7.9. MINOR CHANGE TO OPERATIONAL WORKS AND MATERIAL CHANGE OF USE APPROVAL AT 14 MURPHY STREET

| APPLICATION NO | OP 2024_5601/1 |
| PROPOSAL | Minor Change to Operational Works Development Permit and Material Change of Use Development Permit |
| LOCATION | Road Reserve adjacent 12 Murphy Street PORT DOUGLAS and 14 Murphy Street PORT DOUGLAS |

Figure 3. Approved and proposed driveway alignments

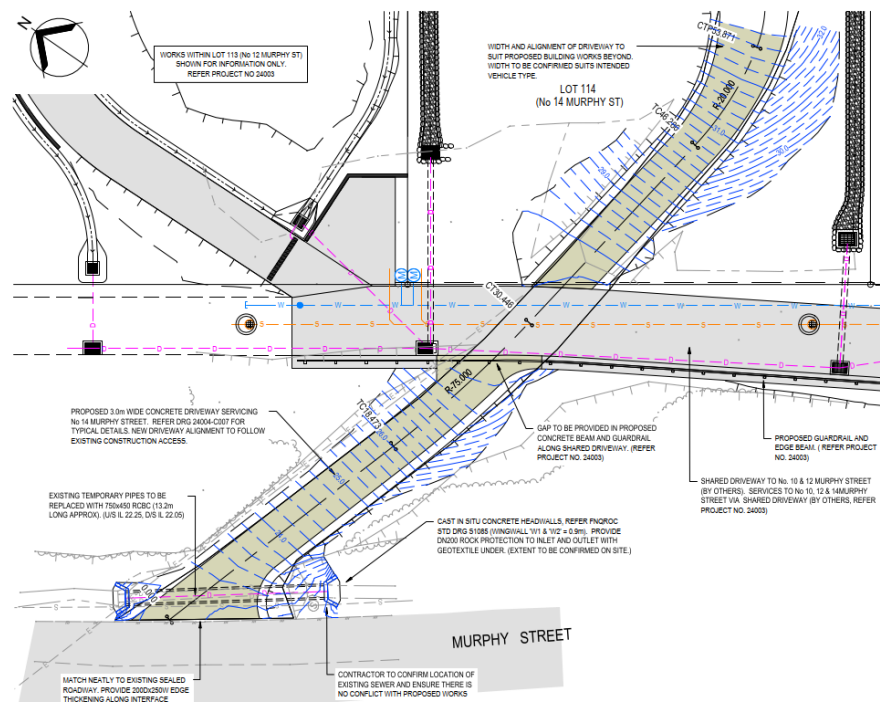
Further, the proposed driveway introduces a vehicle crossing conflict with the existing driveway approval for 10, 12 and 14 and crosses at an acute angle introducing the sight line safety issue. See Figure 3 below detailing the crossing location.

The conflict occurs within the road reserve and therefore would be a liability issue for Council due to the land tenure.

A vehicle accessing 14 Murphy Street via the proposed driveway would be climbing at 29% grade (1v in 3.45h) with the driver on the right-hand side. Any vehicle exiting 10 or 12 Murphy Streets would approach the conflict zone from an acute angle from behind the left-hand side of the entering driver.

Figure 4. Austroads extract detailing intersection angle guideline

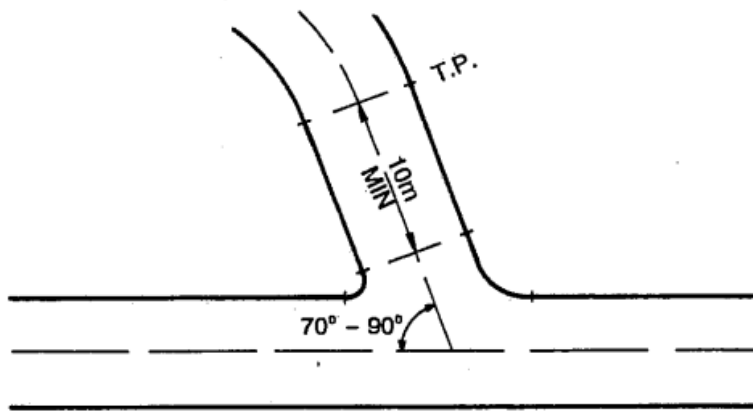
Best practice guidelines Austroads and Queensland Streets advise that approach angles should be as close to 90 degrees as possible and not less than 70 degrees.

The application does not achieve these approach angles. See figure 4 from Austroads below.

The angle between the street centrelines should be **90°**, unless some skewing is essential in which case the **minimum** angle is 70°. The minor street centreline should be straight for a minimum of 10 m from the tangent point of the kerb return.

LONGITUDINAL SECTION - PROPOSED DRIVEWAY (LOT 114)

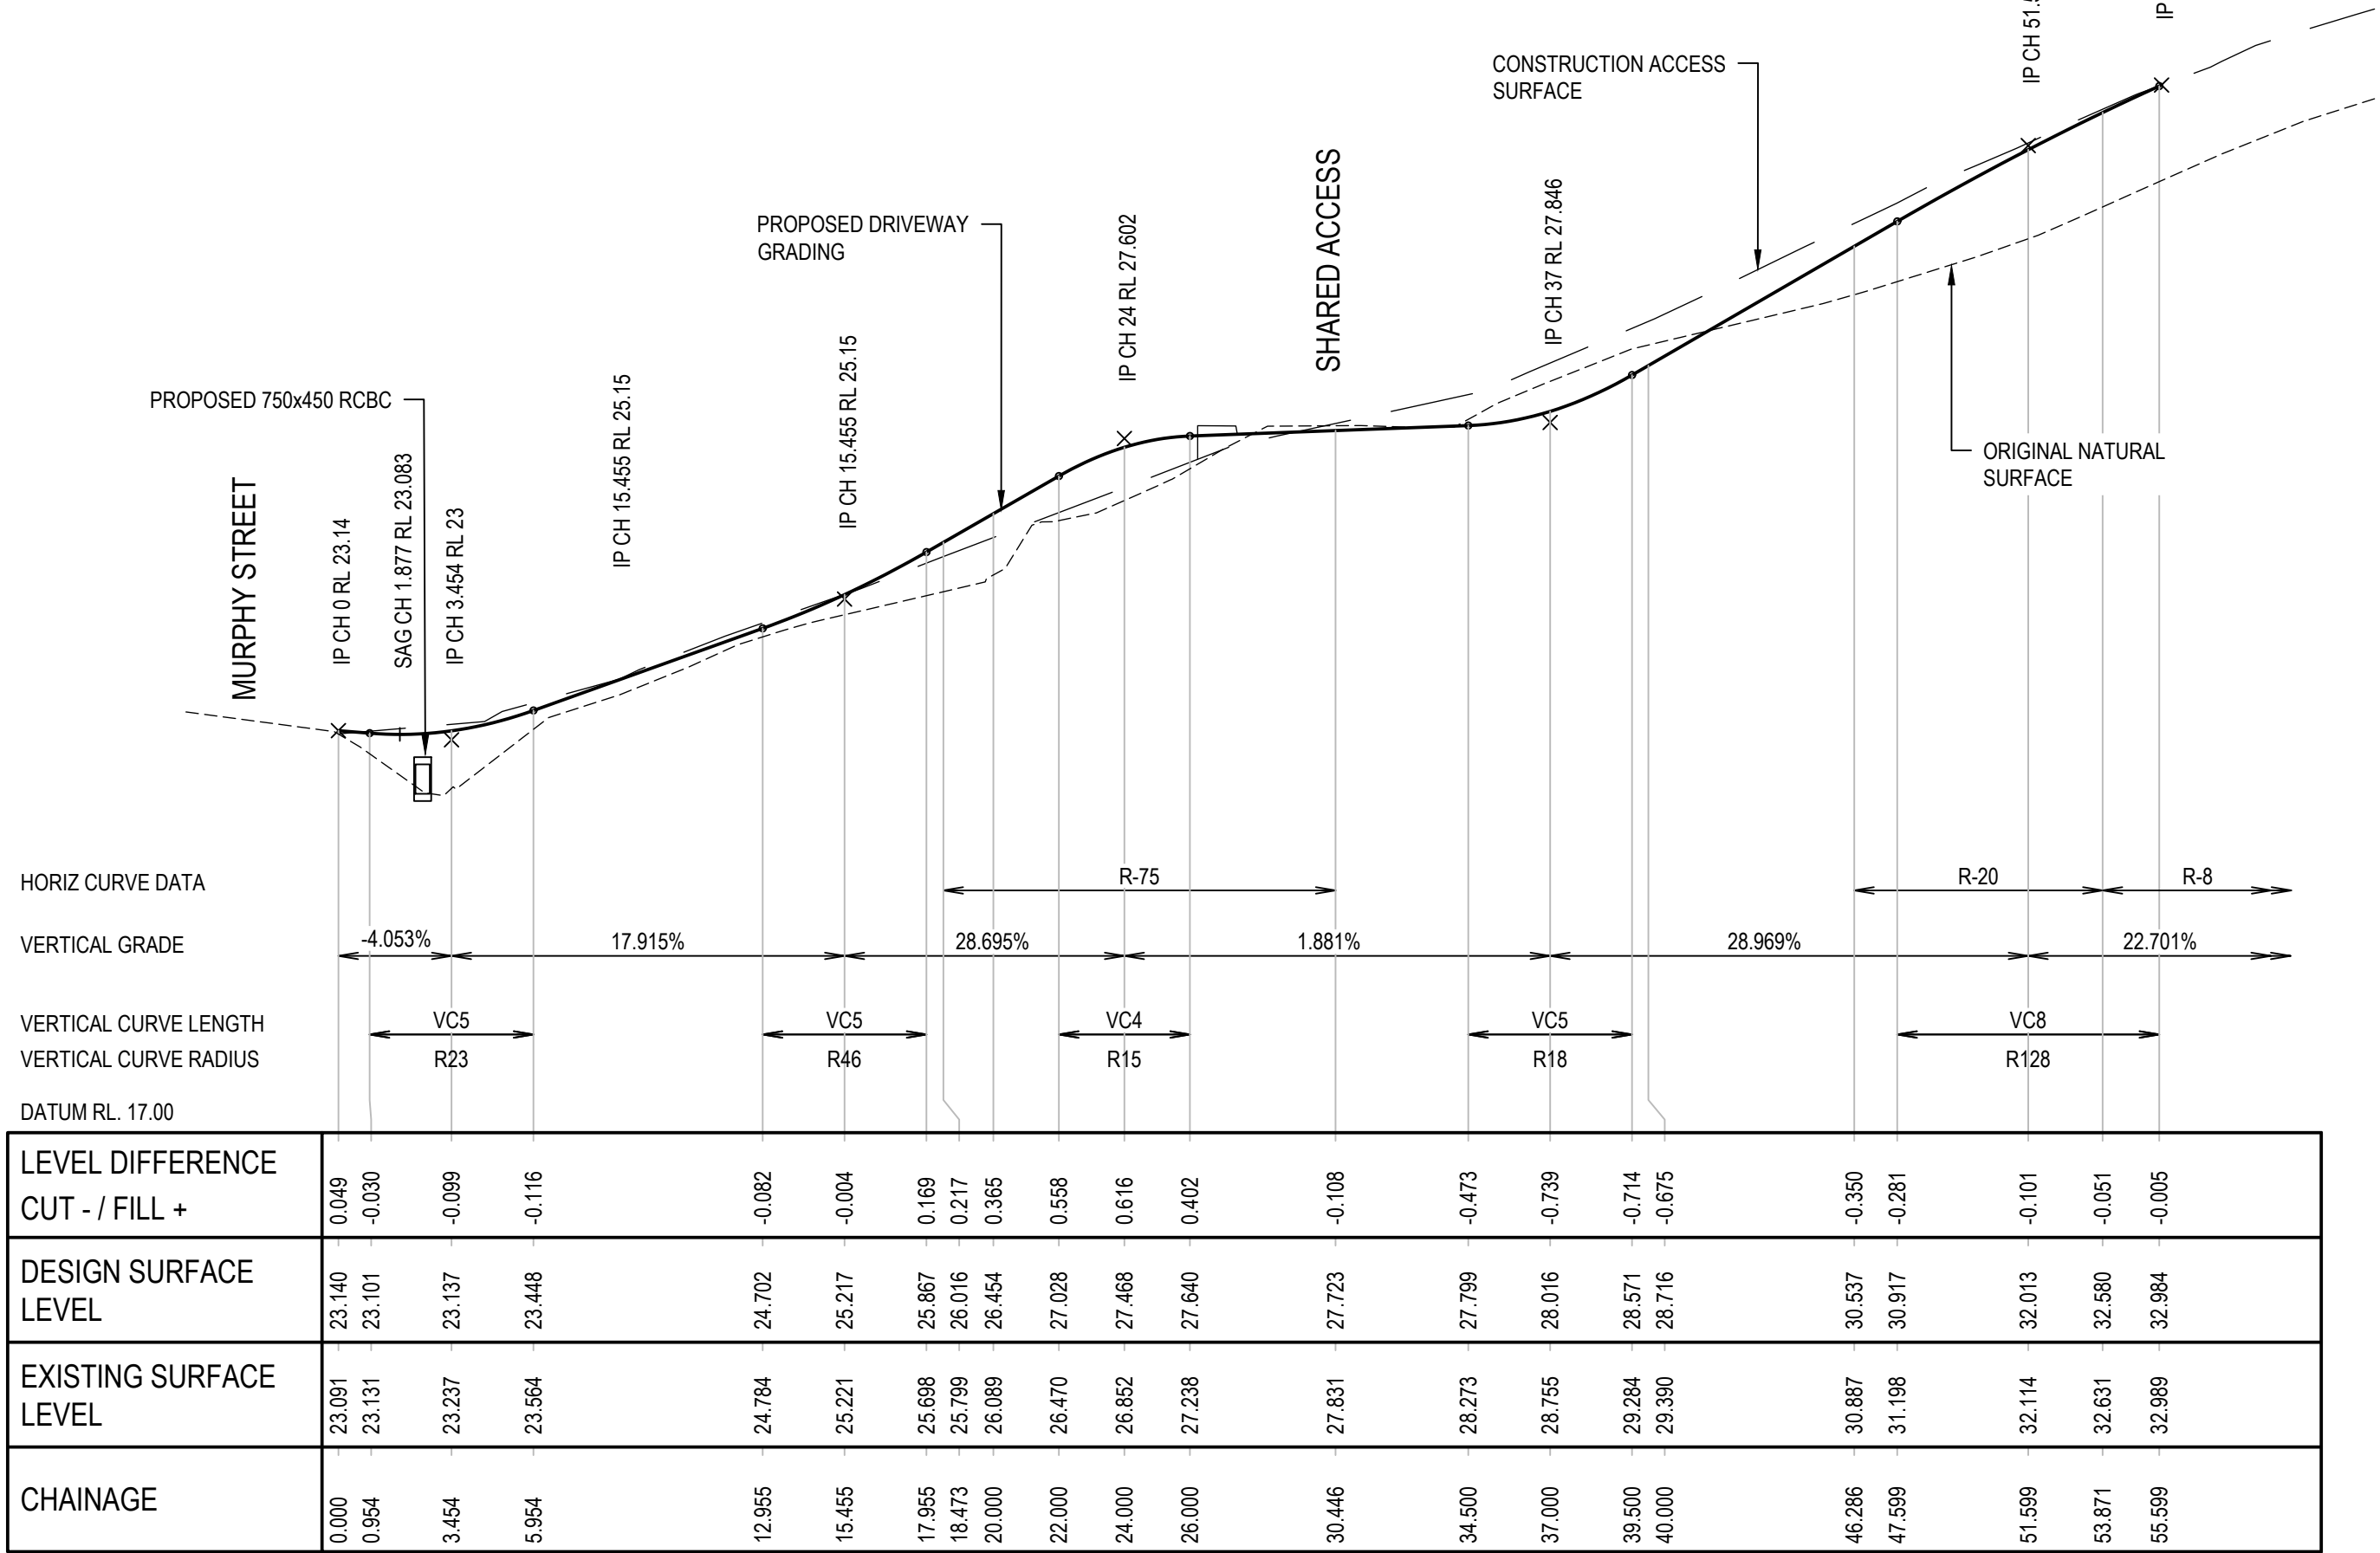
For the lower section of the driveway, the land tenure is road reserve and the Far North Queensland Regional Organisation of Councils (FNQROC) Development Manual would apply. The proposed longitudinal grade exceeds FNQROC maximum road grade of 20%.

This new application seeks a further driveway and steeper grades both in the road reserve and in private land and conflicts with the understanding Officers had at the time of assessing the original application.

The longitudinal grade exceeds AS2890.1 maximum grade of 25% (which applies to domestic driveways **within domestic** properties). See extracts of definitions included below.
